TOWN OF
QUEEN CREEK
ARIZONA

Cielo Noche

K. Hovnanian Homes

RZ 12-061 / SD12-062 / DR12-066

Cielo Noche

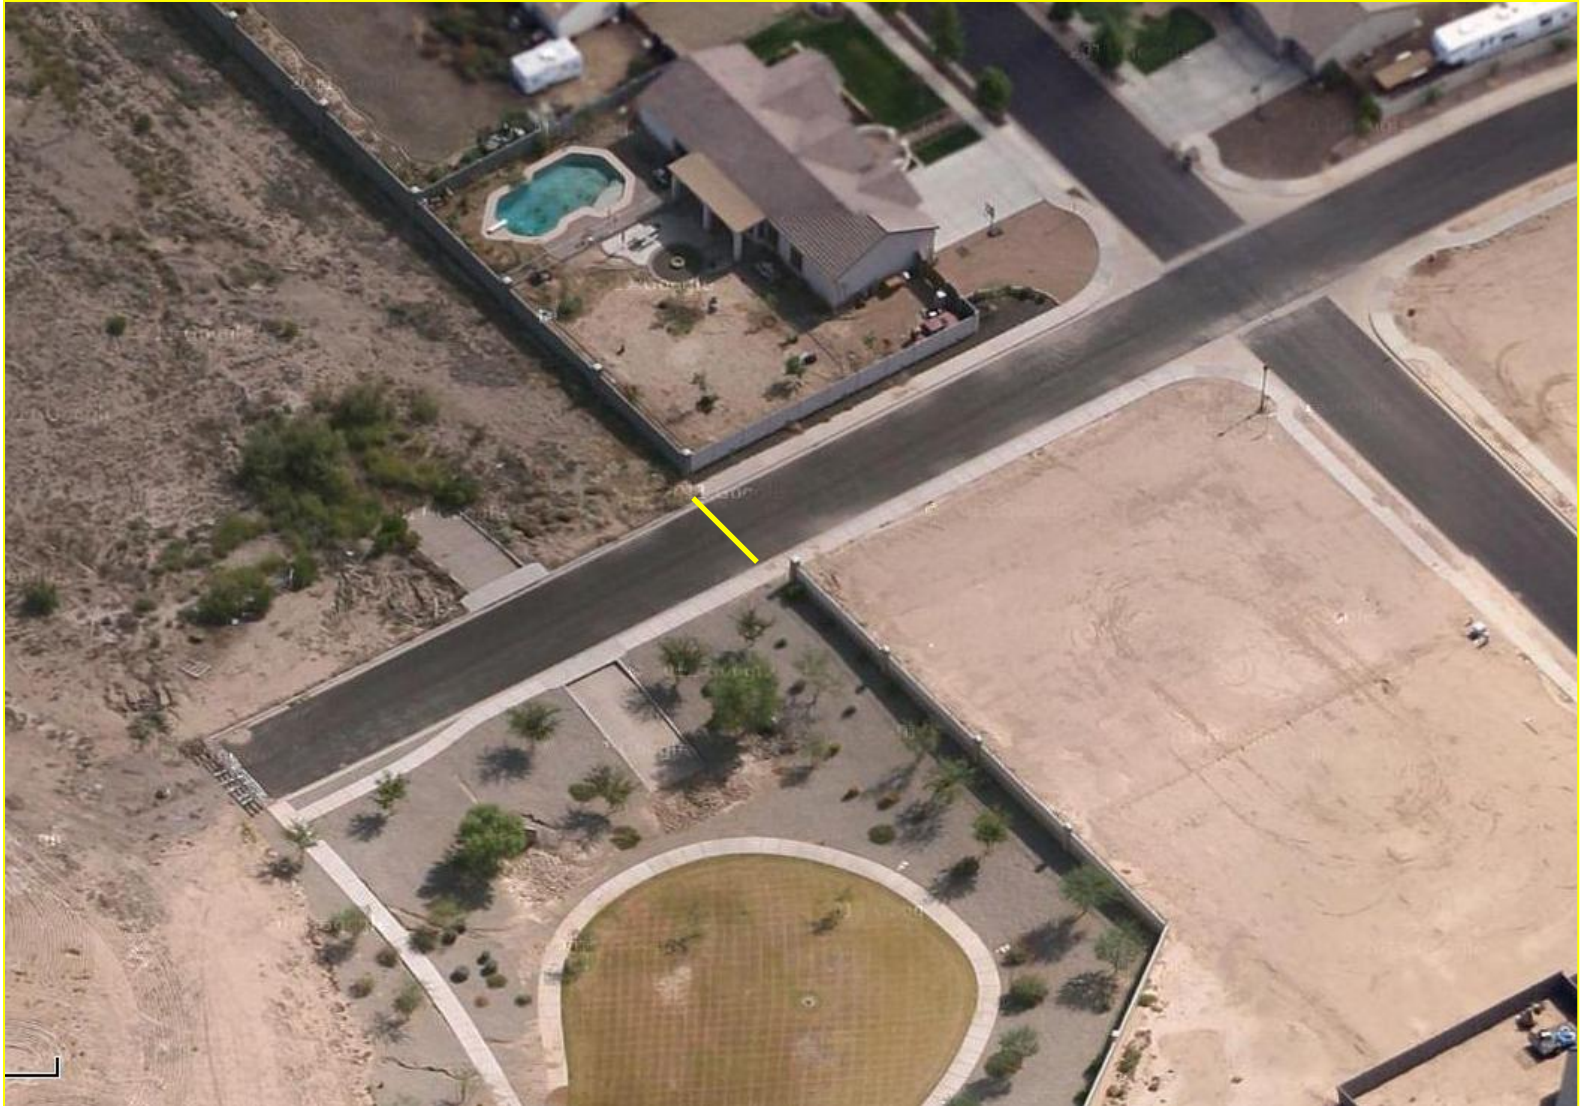
- Support the 43% garage frontage in this case. There was discussion about how to measure this in the future, but recognize that this is a Council policy issue.
- Make the former roadway connections between the subdivisions more aesthetically pleasing.
 - Staff has followed up with Commissioner Nichols on this. Condition of Approval #37 added to address these concerns.
- 2 Story homes along Queen Creek in addition to the lots adjoining the open space
 - Staff added Condition of Approval # 35 and #36 to address these concerns.

No more than 1 in 3 homes to be 2 story, with no more than 2 side by side with a maximum of 10 two story homes.

No 2 story homes to be built on lots 29, and 48 – 50.
